SERVICE INSTRUCTION

RUNNING MODIFICATIONS ON

ROTAX® ENGINE TYPE 912/914 (SERIES)

SI-912-020R6

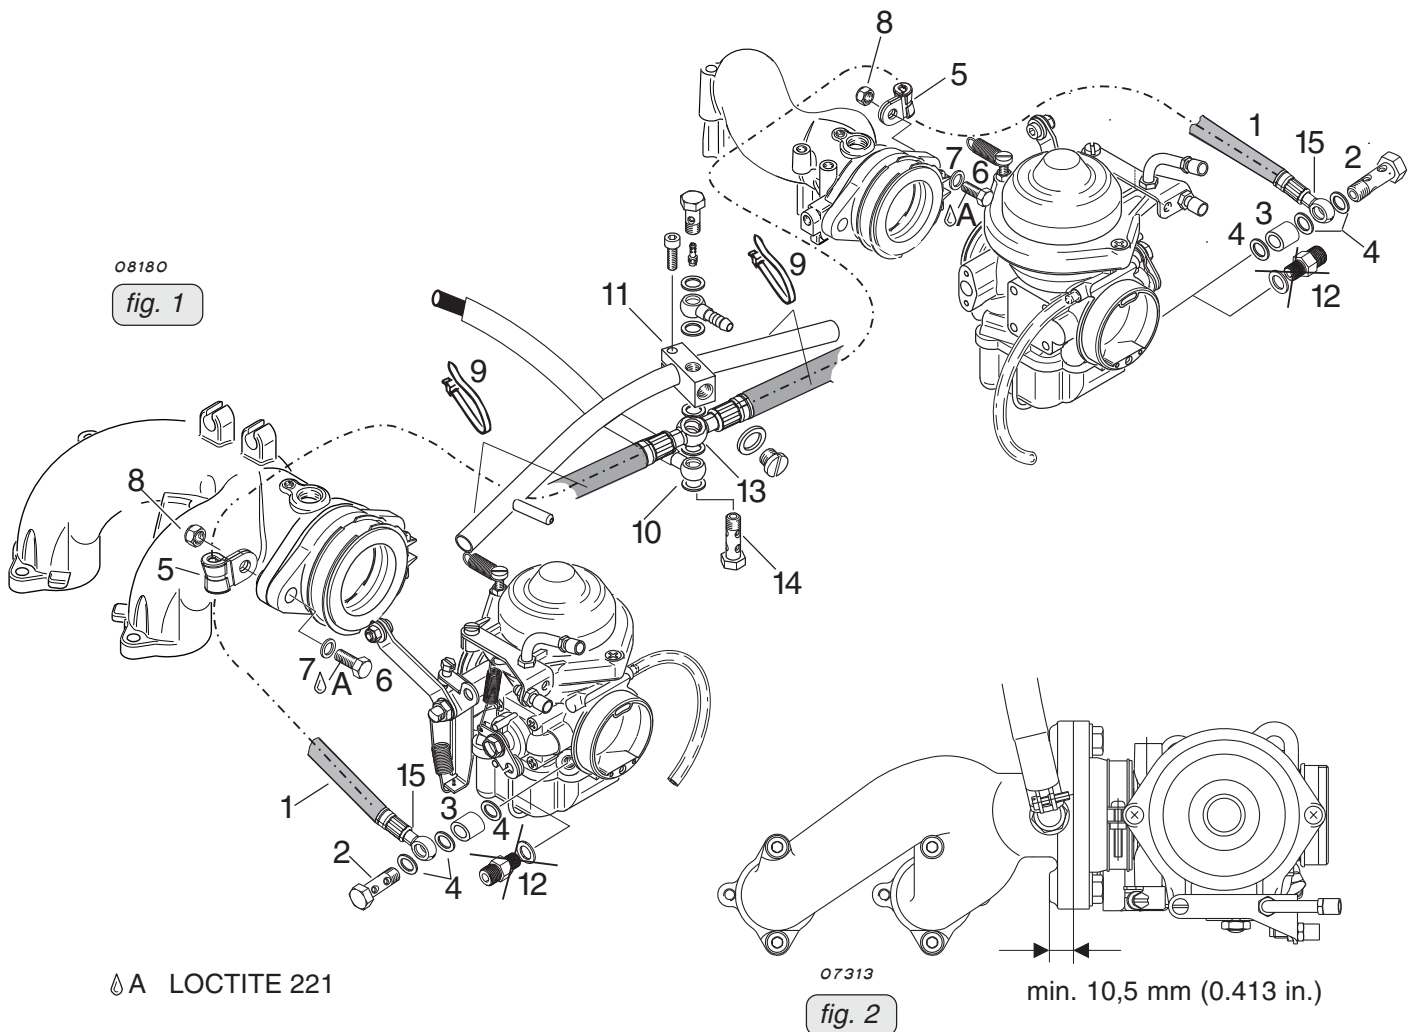
1) Introduction of a new flexible fuel line assy. part no. 874911 for ROTAX® 912 Series

In the course of continuous development and for better assembly and maintenance a new flexible fuel line (part no. 874910) has been introduced.

Installation of this new fuel line requires the following modifications:

- mechanical machining at the intake manifold for the attachment of the cable clamp. At engine repair/general overhaul be aware that the fixation of the flexible fuel line needs an appropriate contact surface. If necessary replace the intake manifold or machine the contact surface according to the following instruction.

- Install the flexible fuel line (1) with the double ring hose nipple (13) and sealing ring (10) on the clamp block (11). Tightening torque of banjo screw (14) 10 Nm (90 in. lb.) (see fig. 1).

- Install the ring hose nipple (15) with distance sleeve (3) and sealing ring (4) on the carburetors. Tightening torque of banjo screw (2) 10 Nm (90 in. lb.)

- For installation on an old style intake manifold perform the following: Remove the intake manifold and machine the nut/clamp contact area until the surface is parallel with the sealing surface of the carb socket. The thickness of the material must not be dressed down less than 10,5 mm (0.413 in.) and should be smooth and flat so that the nut/clamp assembly has an even contact surface (see fig. 2).

- Ensure proper support of the flexible fuel line. Install Hex. screw (6) and washer (7) with 15 Nm (133 in. lb.). Install the cable clamp (5) at the hex. screw (6) of the carburetor socket with the hex. nut (8). Tightening torque of hex. nut (8) 24 Nm (213 in. lb.)

fig. 1

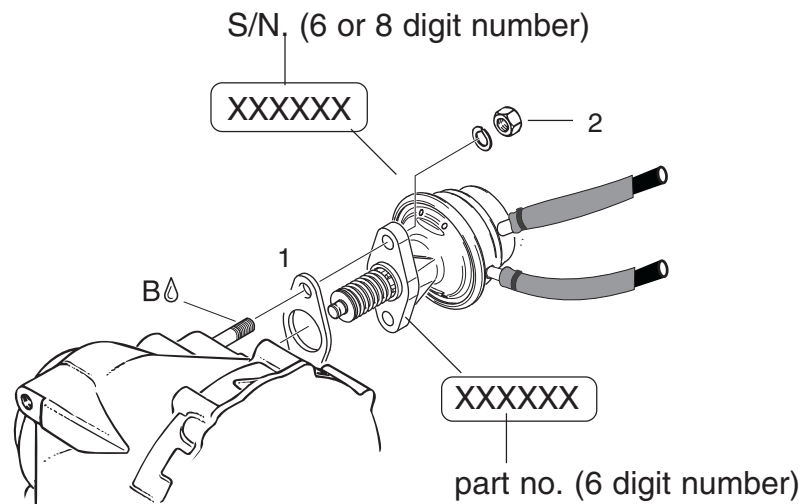
In the course of continuous development a new gasket (1) (part no. 950226) has been introduced.

The gasket is interchangeable.

- ◆ NOTE: On the sealing surfaces of the gearbox housing and the fuel pump no sealing compound has to be used.

08371
fig. 1

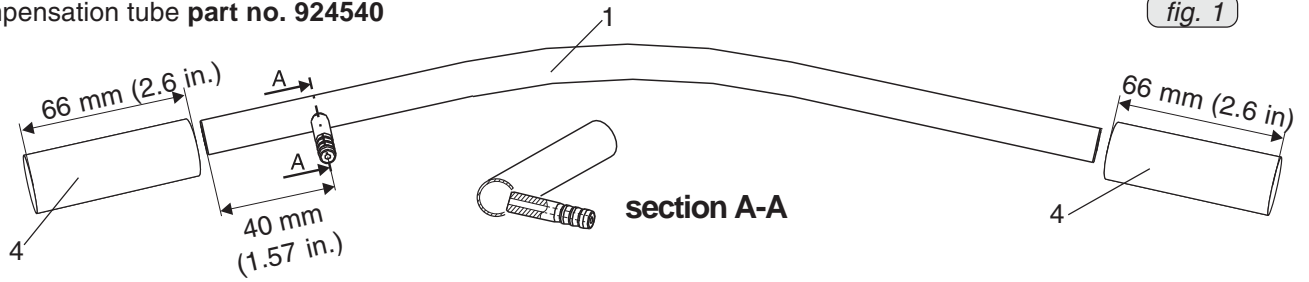
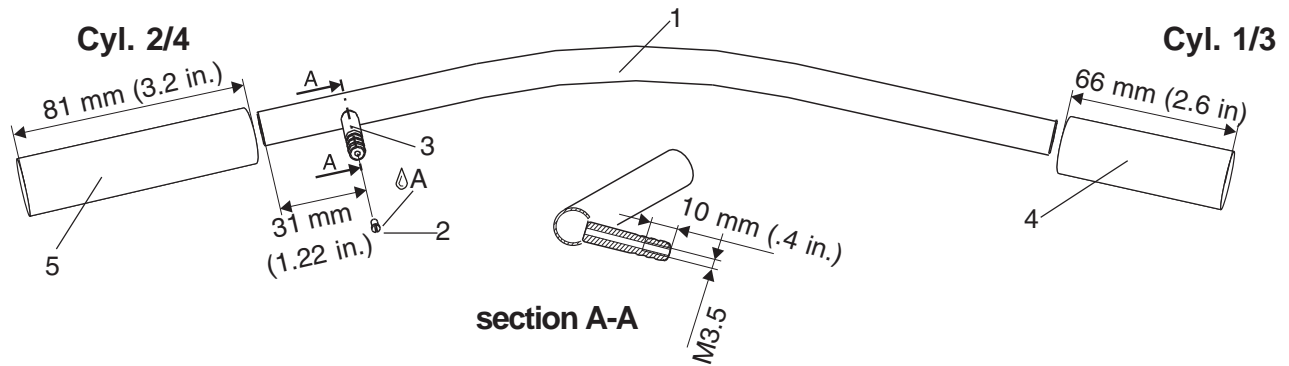
In the course of continuous development a new compensation tube (1) (part no. 924541) has been introduced which the synchronization to make it easier, the tube must not removed.

- position of connection fitting (3) on compensation tube remains approximate constant
- additional screw (2) part no. 940980 for connection fitting (3)
- new tube (4) part no. 956143 (5) part no. 956141

fig. 2

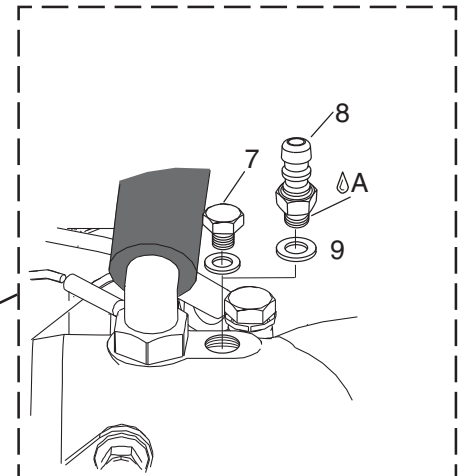
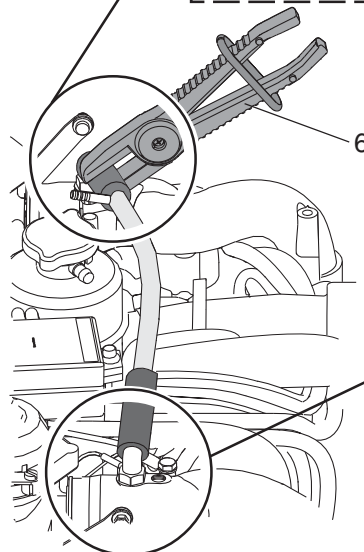
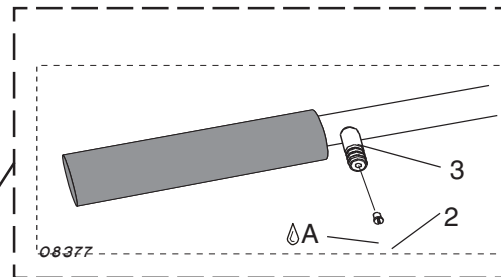
1. Install the vacuum gauge.
2. Clamp the tube with hose clamping pliers (6). Observe the position! The tube (1) must not removed.
3. Unscrew the screw (7).
4. Install the hose nipple M6 (8) with the sealing ring (9).
5. After synchronization tightened the screw M6x6 (7) with LOCTITE 221.

08830
fig. 3

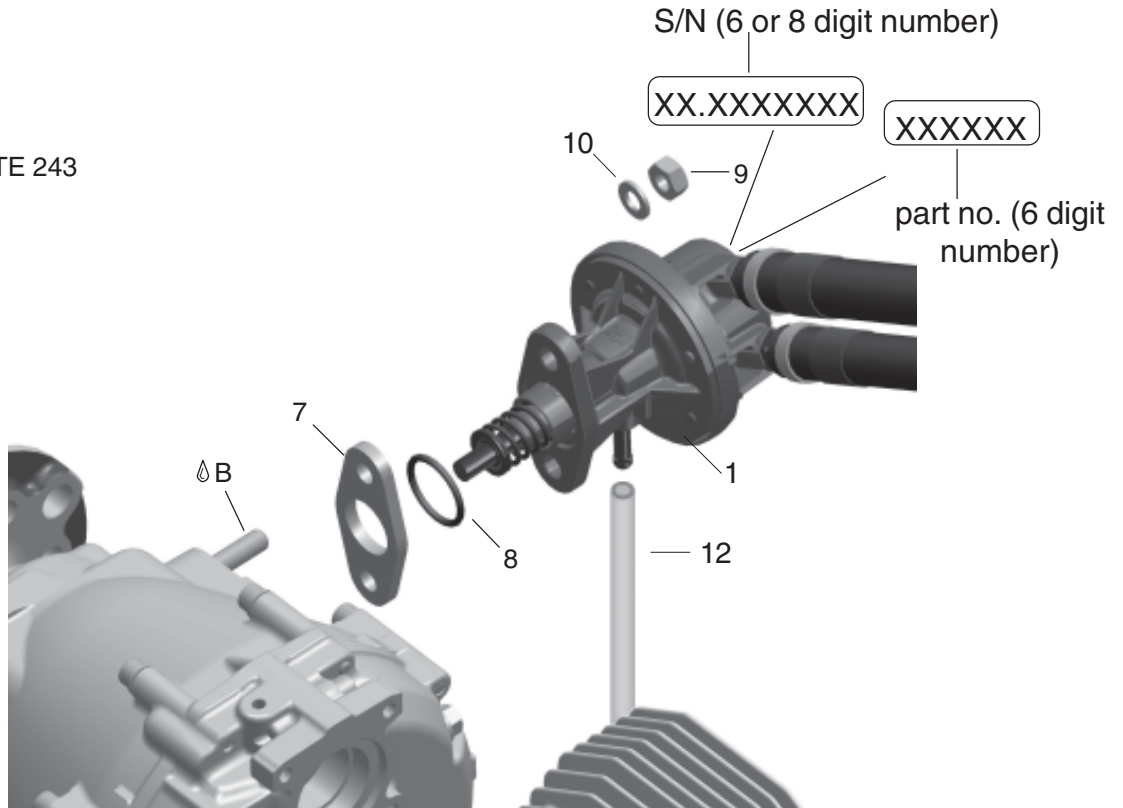
In the course of continuous development and for better assembly and maintenance a new fuel pump assy. (part no. 893110 and/or part no. 893114) has been introduced.

Connecting to fuel pump (1) with push-on fittings. See fig.1.

Connecting to fuel pump (1) with attached hoses. See fig. 2.

08684
fig. 1

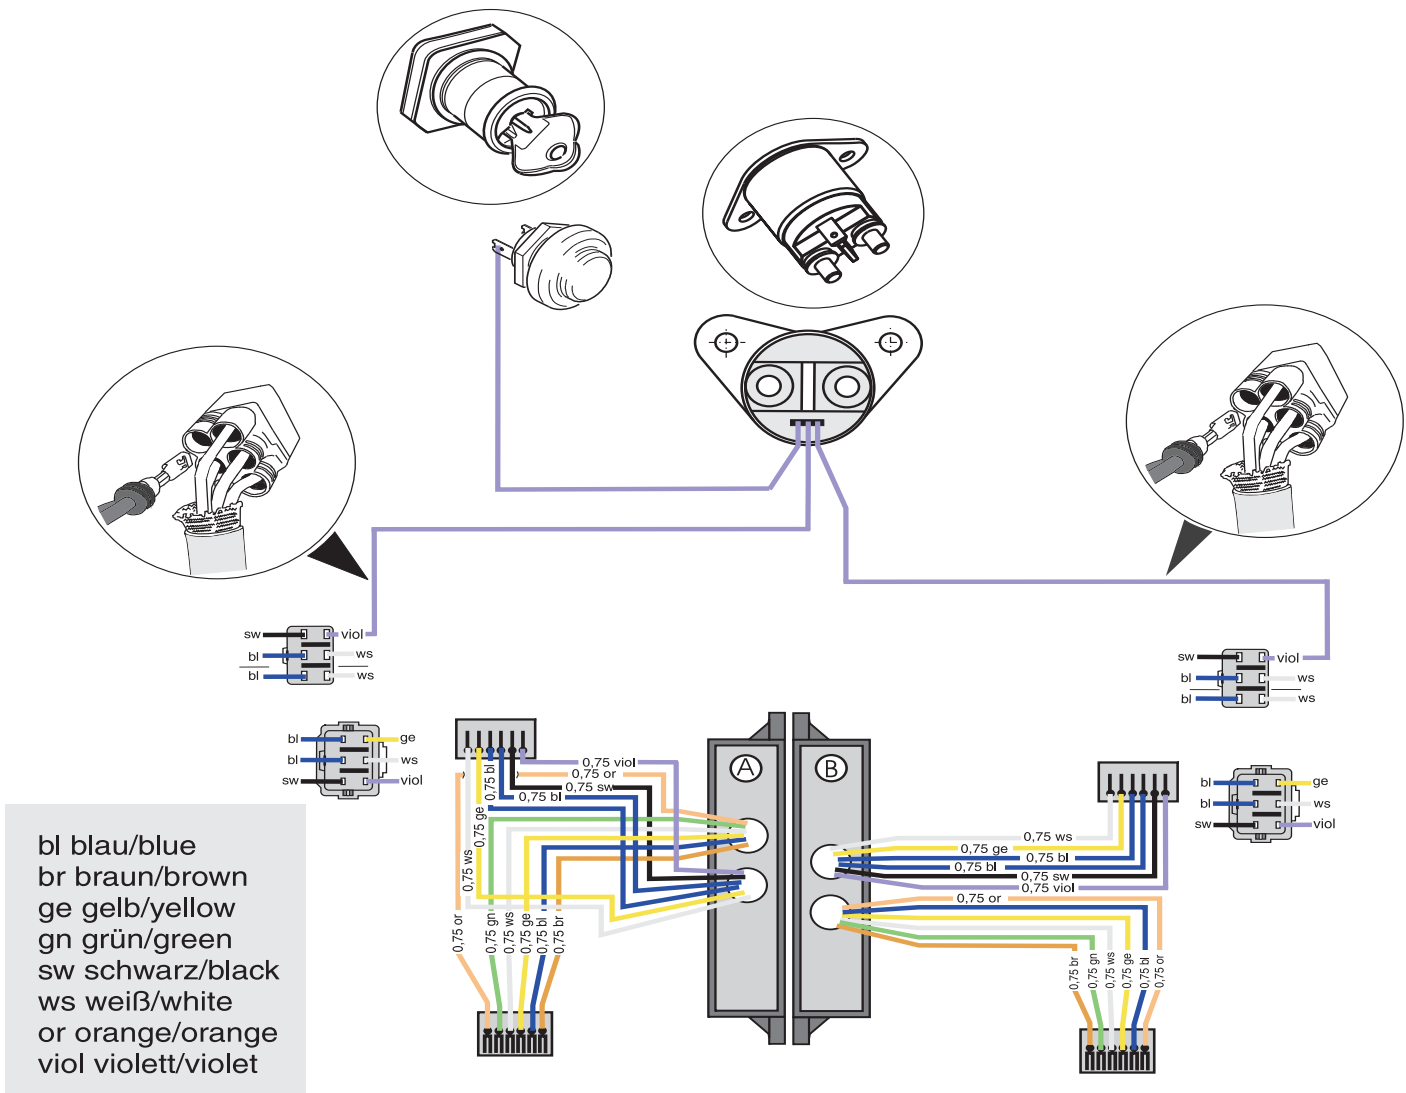
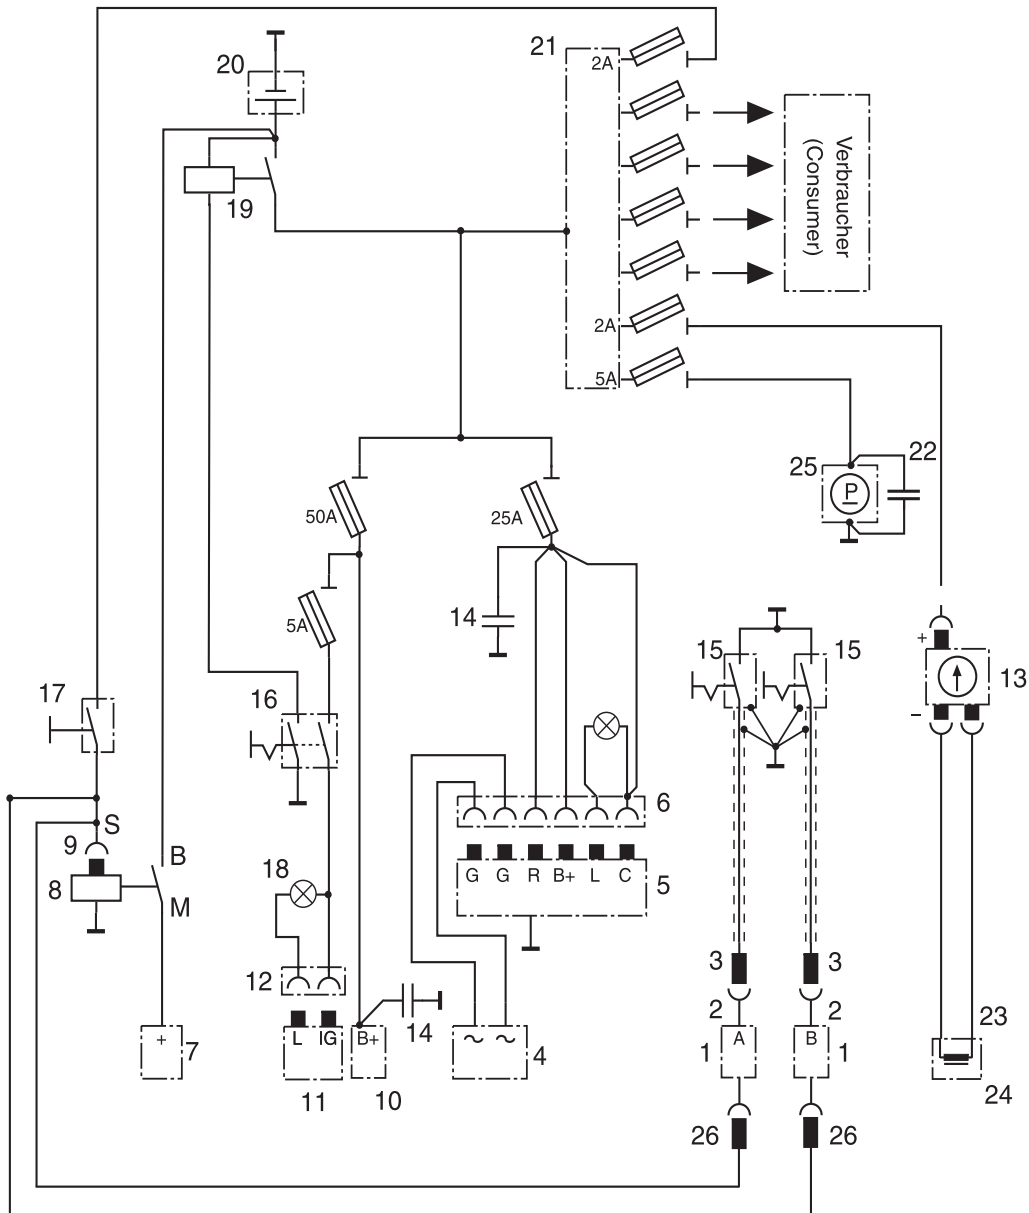
In the course of further development and standardization an electronic module for delayed start up ignition timing has been introduced. This module can be activated by a 12 V signal. Without this optional 12V activation the function works the same way as on the well-proven previous module.

- 1 wire of each module circuit A and circuit B (6-pole) to start relay control signal wire (see position 26 in fig. 1) must be supplied by the aircraft manufacturer. Therefore the rubber plug of the pin terminal must be removed before!
- Time factor for delaying ignition timing at start until switching to advanced ignition: After starting the engine and as soon as the starter/relay is not powered anymore, the engine continues to further run for 3-8 seconds with delayed ignition.
- Do not connect the signal wire to the electric starter motor - as the circuit has not voltage protection.
- Do not power the advanced start terminal permanently with 12V. The delay timer function would be bypassed and charging speed might vary (depending on internal tolerances, trigger gap etc.).
